SCHEDULE B - WASTEWATER SYSTEM - BID SET  
 VTTRANS PROJECT #AV157046-301  
 JUNE 2016

NEWPORT STATE AIRPORT COVENTRY, VERMONT NEWPORT WASTEWATER		
SITE 2 - MOUND E DETAIL		
SCALE: 1" = 20'	DESIGN: TCB	MD2-02 29 of 96
DRAWN: TCB	PROJECT: 17958.01	
CHECKED: BLS	DATE: JUNE, 2014

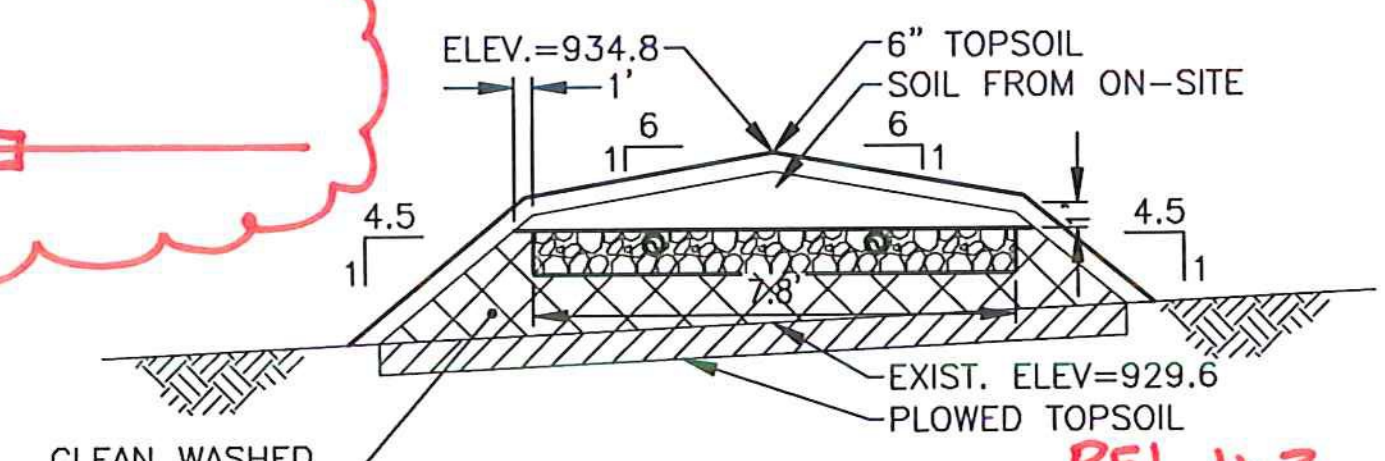
*RFI #7*  
 MANIFOLD DISTRIBUTION MANIFOLD

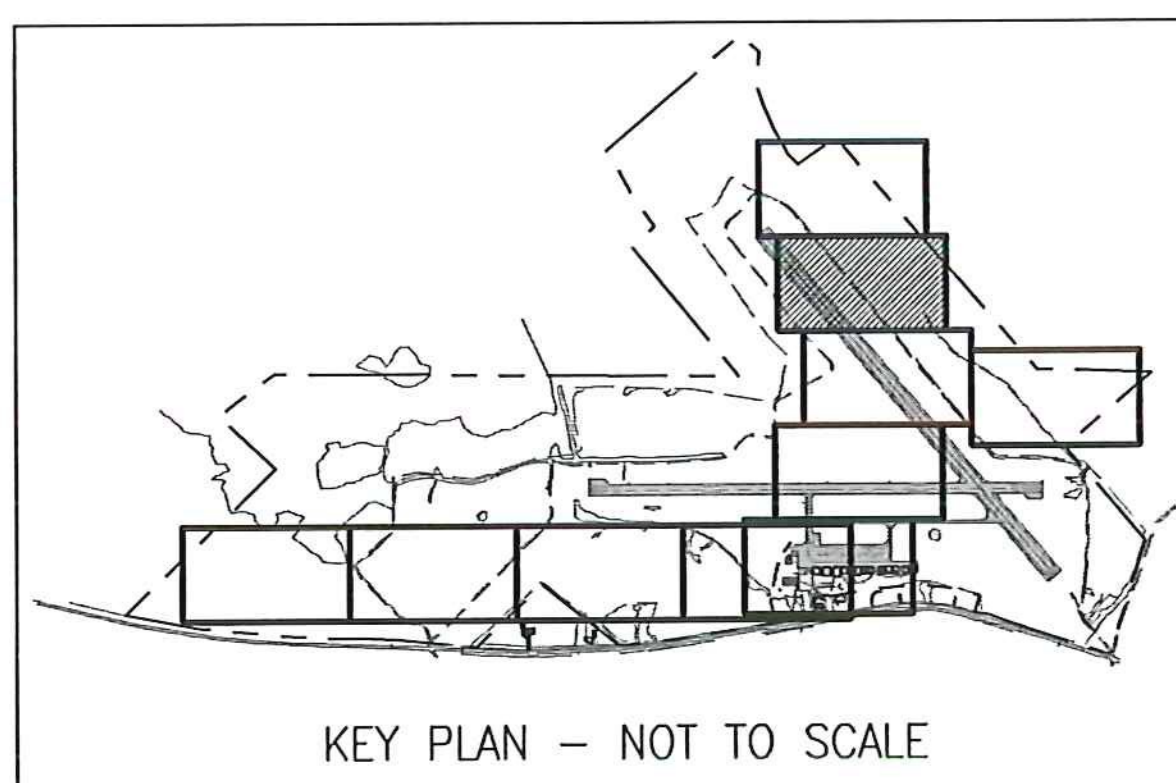
*RFI #3*  
 EX. TOPSOIL THK. RFI #6 NO CHANGE TO GRADES
